**Reference: Dunkin Donuts/Valvoline – Estero
DOS2016-E001 – Small DO
Response to DRB Comments**

RE: Dunkin Donuts / Valvoline Estero

Valvoline Instant Oil Change (VIOC)
Grand Oak Shoppes Blvd.
Estero, Florida 33928
6/20/16
Rev. 7/13/16

Design Revision chronology since first "Design Review Board Meeting"

Valvoline Instant Oil Change
 Shoppes of Grande Oak
 Estero, Florida 33928

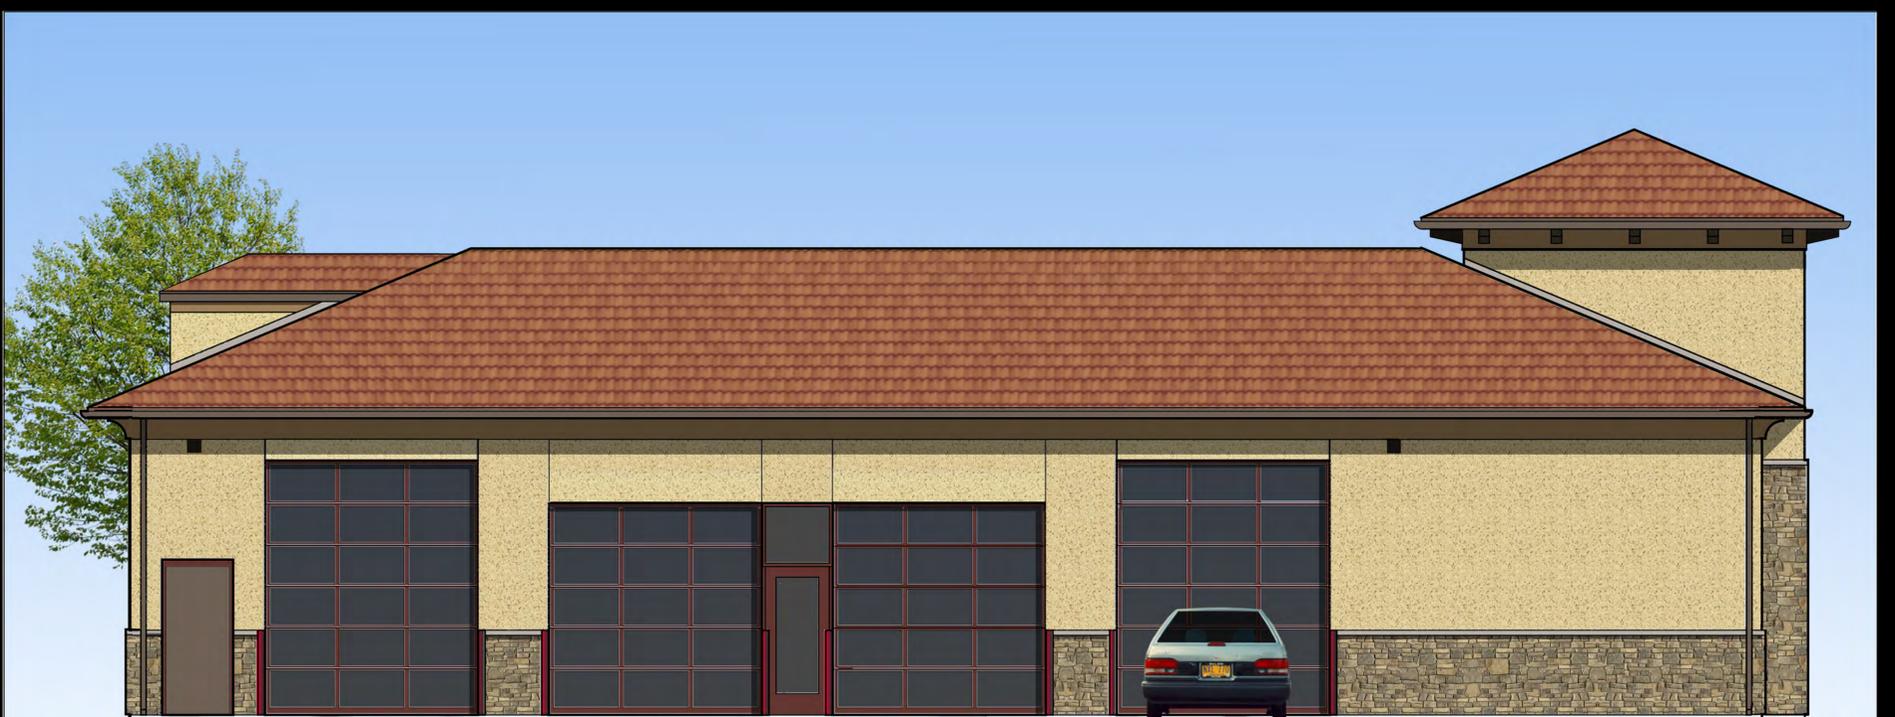
1. Additional dormer added to the South Elevation (end of shop area – away from tower)
2. All “VIOC brand signs” removed with exception of 2 faces of Tower. A note added to drawing A2.1 Elevations regarding signage on b/w elevations requiring separate sign application and approval.
3. More “faux beams” (corbels) added at all 4 sides of tower.
4. Material color change – all aluminum / glass entries, storefront, and overhead doors shall be anodized bronze as opposed to mill finish aluminum (silver). Note added to drawing A2.1 Elevations.
5. VIOC Dumpster door shall match the Dunkin Donuts as nearly as possible.

LA-1

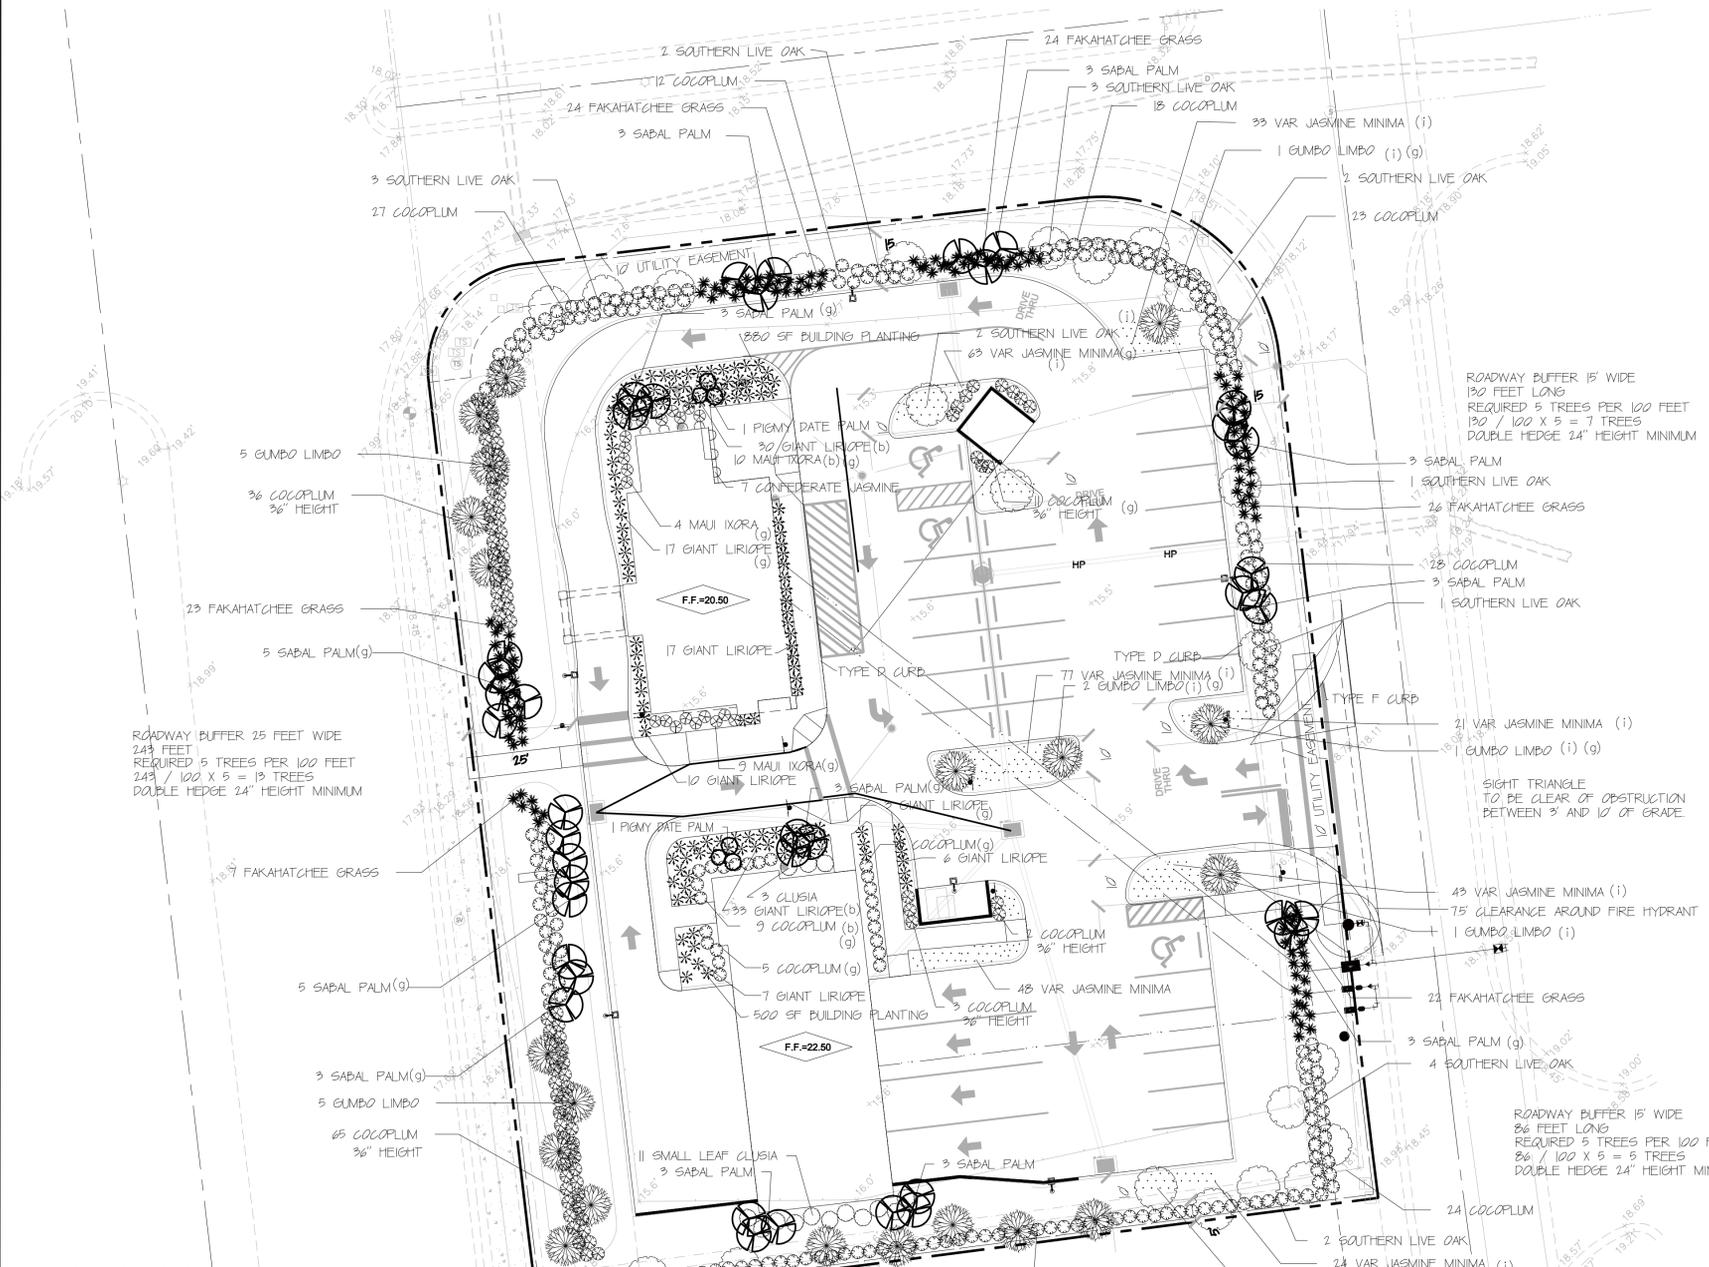
1. Added vines around freezer.
2. Added mid-size planting in bed adjacent to freezer.
3. Added more of the larger size shrub to the berm planting adjacent to Valvoline. Moved the shrubs toward the Right-of-Way to the top of the berm.

4. Added plantings on the south side of Valvoline.
5. Added screening to the waste oil station by Valvoline.
6. Moved the Sabal Palms on the north side of Valvoline and added mid-size planting in the planting bed.
